RTHA-SB-19

Library	Service Literature
Product Section	Refrigeration
Product	Rotary Liquid Chillers
Model	RTHA
Literature Type	General Service Bulletin
Sequence	19
Date	November 1993
File No.	SV-RF-RLC-RTHA-SB-19-1193
Supersedes	Original

Subject: RTHA bF2 Low Oil Flow Diagnostic.

Figure 1
Differential Pressure Switch Rewiring for
Units Without Active Oil Return

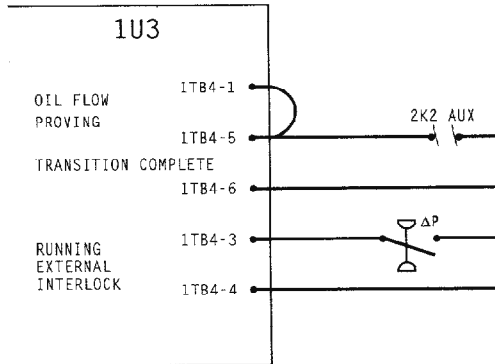
For units without active oil return, refer to Figure 1 and follow the procedures below:

- a. Remove the Delta-P switch from 1TB4-1 and 1TB4-5 and place a jumper between these two terminals.
- b. Change the Delta-P switch from normally-closed to normally-open.
- c. Rewire the Delta-P switch to the "Running External Interlock" terminals, 1TB4-3 and 1TB4-4.
- d. Restore power and proceed to Step 7.

Figure 2
Differential Pressure Switch Rewiring for
Units With Active Oil Return

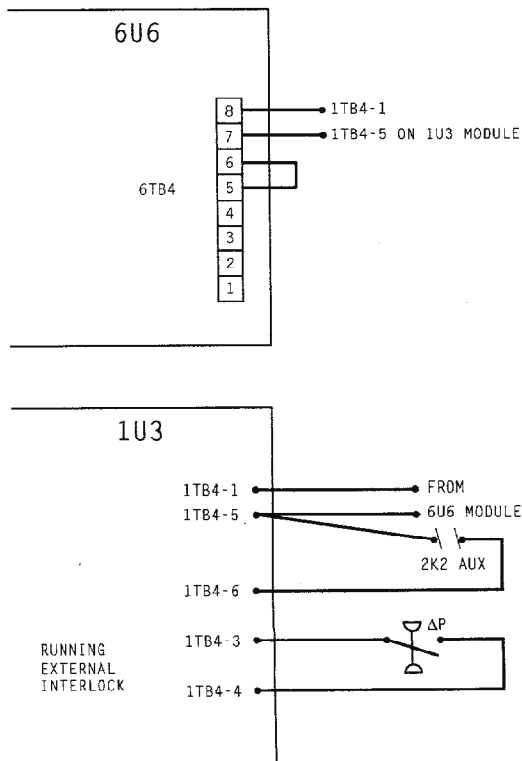
For units with active oil return, refer to Figure 2 and follow the procedures below:

- a. Disconnect power.
- b. Remove the Delta-P switch from 6TB4-5 and 6TB4-6 on the active oil return module (6U6) and place a jumper between these two terminals.
- c. Change the Delta-P switch from normally-closed to normally-open.
- d. Rewire the Delta-P switch to the "Running External Interlock" terminals, 1TB4-3 and 1TB4-4 on the 1U3 module. Additional wire may be required.
- e. Restore power and proceed to Step 7.

Figure 3
Additional Relay to
Eliminate Chattering of 2K2 Aux.

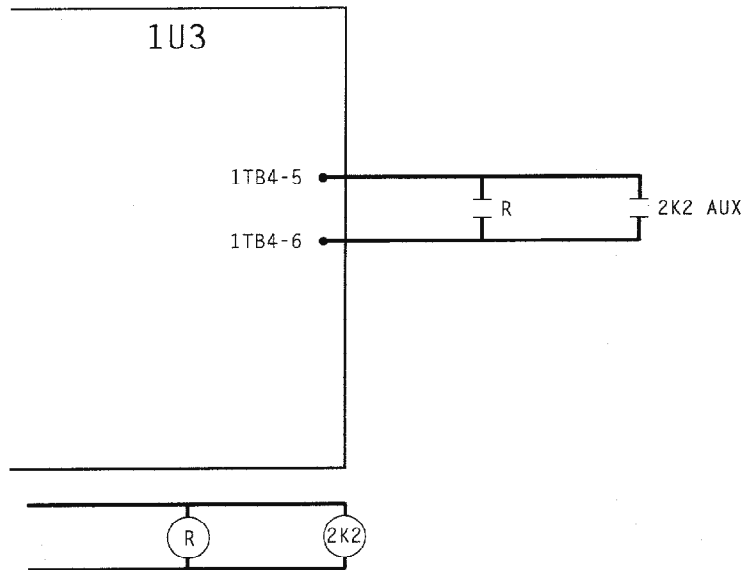
10. The additional relay must have contacts rated for a dry DC circuit. RLY-847 can be used for this purpose.

Wire the relay coil in parallel with the 2k2 contactor coil, with the N.O. contacts of the relay wired in parallel with the 2k2 auxiliary contacts. Refer to Figure 3 for details.

Figure 4
Coupling Locations on the Evaporator

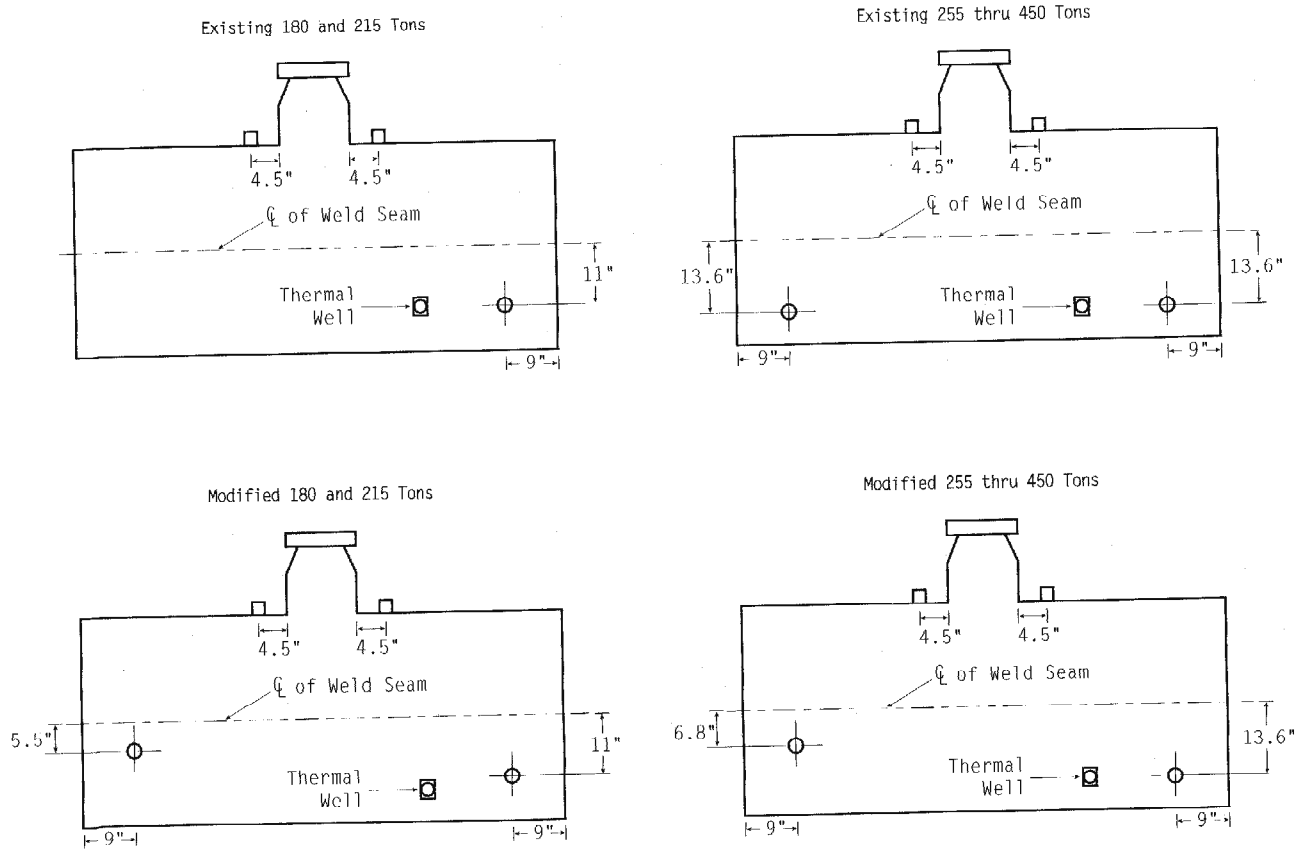
Note: Refer to Figures 4 and 5 for eductor dimensions and tubing.

1. Recover refrigerant (refrigerant can be stored in the condenser if the unit has isolation valves).
2. Weld couplings to the evaporator shell, as follows:

- a. On 180 ton and 215 ton units, weld a 3/4-inch coupling to the top of the evaporator, 4.5 inches from the suction connection. Also, weld a 1/2-inch coupling 9 inches from the tube sheet and 5.5 inches down from the center of the weld, on the side closest to the condenser shell. Use a 0.19-inch fillet weld on both couplings.

- b. On the 255 ton to 450 ton units, weld a 1/2-inch coupling 9 inches from the tube sheet and 6.8 inches down from the center of the weld, on the side closest to the condenser shell and re-use the 3/4-inch coupling that is already mounted on the top of the evaporator. Use a 0.19-inch fillet weld on the coupling.

- c. Leak test the coupling welds.
 - d. Drill a 0.85-inch hole through the 3/4-inch coupling and a 0.70-inch hole through the 1/2-inch coupling. **Use a drill stop to prevent damage to the tubes.**

**Figure 5
Eductor Tubing**

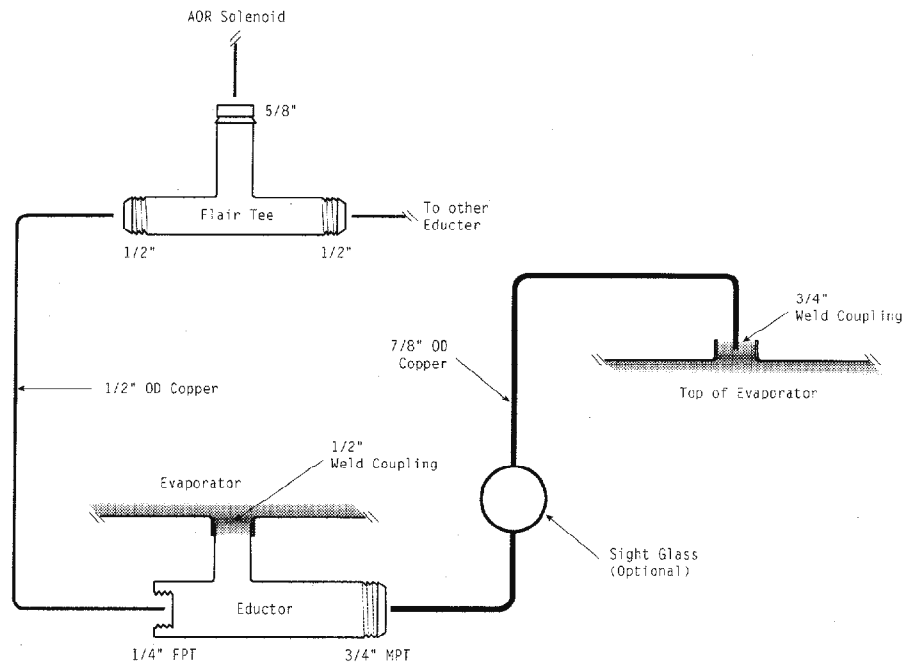
4. Screw the 1/2-inch MPT of the eductor into the 1/2-inch coupling on the side of the evaporator. Use 7/8-inch copper tube between the 3/4-inch male connection of the eductor and the 3/4-inch coupling on top of the evaporator. See Figure 5.

5. On the 180-215 ton units, modify the condenser motive line by adding a 1/2 x 5/8 x 1/2-inch tee with a 45 degree flare downstream of the solenoid and a 1/2-inch copper line. Refer to Figure 5.

6. On the 180-215 ton units, use 1/2-inch copper tubing between the 1/2-inch tee and the inlet of the eductor (1/4-inch FPT).
7. On the 255-450 ton units, plug the old weld coupling, which is no longer being used, and re-use the interconnecting piping between the eductor.

**Figure 6
Re-Wiring of the 6U6 Module**

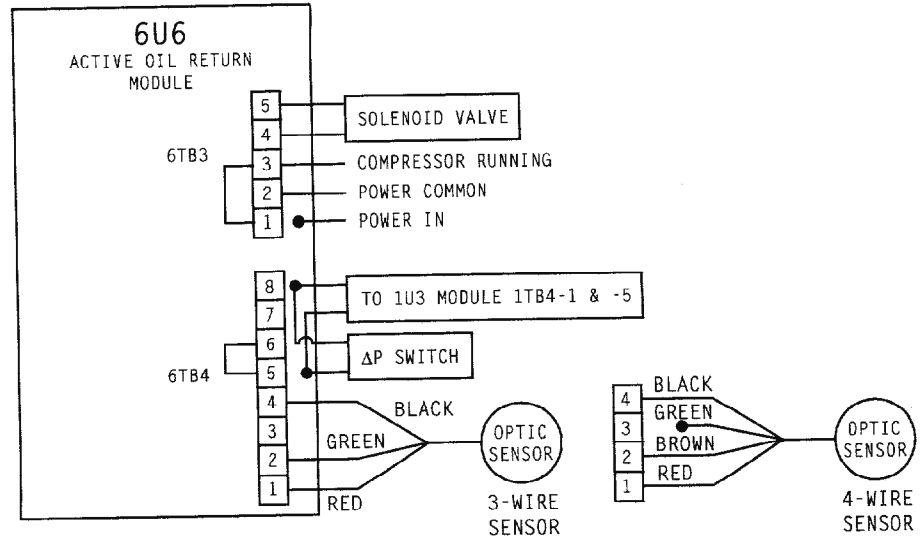
Refer to Figure 6.

1. Be sure that all power to the Control Panel is de-energized.
2. Disconnect the wire at 6TB3-1 and cap the wire.
3. Install a jumper wire between 6TB3-1 and 6TB3-3.
4. Disconnect the wires at 6TB4-6 and 6TB4-8, tie them together and cap them.
5. Disconnect the wires at 6TB4-5 and 6TB4-7, tie them together and cap them.
6. Install a jumper wire between 6TB4-5 and 6TB4-6. Terminals 6TB4-7 and 6TB4-8 will remain bare.
7. Restore power to the Control Panel.

The re-wire of the 6U6 module will allow the differential pressure switch to continue protecting the unit from a restriction in the hydraulic line. The change is in the operation of the Active Oil Return module (6U6).
